APPLICATION NO.	FILING DATE	FIRST NAMED INVENTOR	ATTORNEY DOCKET NO.	CONFIRMATION NO.
09/852,880	05/10/2001	Geroge M. Savagle	FEM-0051	5169

Office Action Summary	Application No. 09/852,880	Applicant(s) SAVAGLE ET AL.	
	Examiner Manuel Mendez	Art Unit 3763

DETAILED ACTION

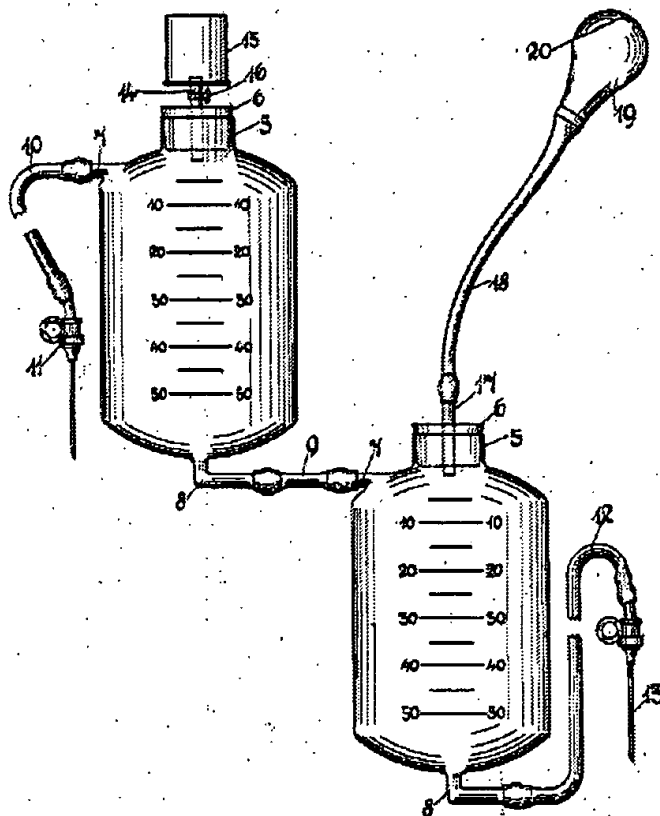
Claims 36 and 37 are rejected under 35 U.S.C. 102(b) as being anticipated by Schmidt, et al. The cited patent discloses a first inflow container for storing fluid introduced into the patient; a pump coupled to the first inflow container for assisting fluid from the first inflow container into the patient; and an outflow container for storing fluid collected from the patient.

The figure above shows a first inflow container (5), a pump (19) coupled to the first inflow container (5), and an outflow container (3). Accordingly, Schmidt, et al, anticipates claims 36 and 37.

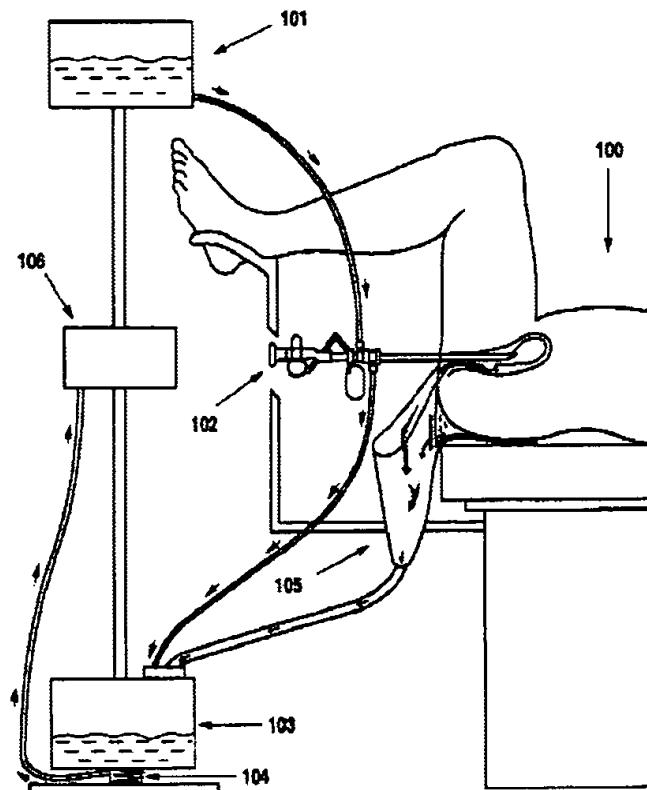
Claims 38-41 are rejected under 35 U.S.C. 103(a) as being unpatentable over Vancaillie, et al., U.S. Patent Number 5,522,805 in view of TU, U.S. Patent Number 4,457,747. The Vancaillie, et al. Patent shows in figure 9, a surgical fluid monitor comprising of a first inflow container (101) and an outflow container (103).

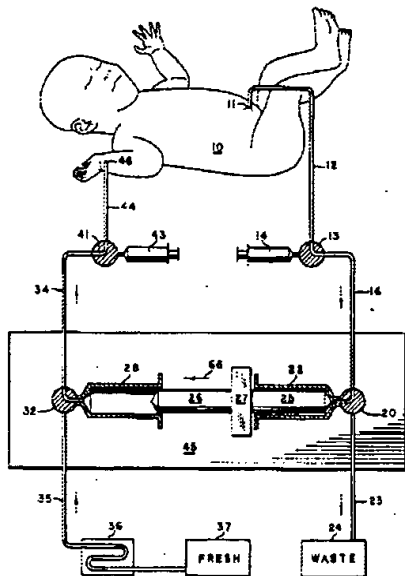
As shown above, the apparatus uses gravity as a substitute for a pump to infuse fluids into the body of the patient. The examiner of record introduces the TU Patent to demonstrate that it is well known that gravity infusion and pump infusion are substitutable conventional alternatives.

Please note in figure 2 of the TU Patent, the use of a pump to infuse and to suction fluids to and from the body. By using a pump, the Tu Patent eliminates the requirement of a pole to increase or decrease flow rate. Accordingly a person of ordinary skill in the art would have considered gravity infusion and pump infusion obvious design alternatives.
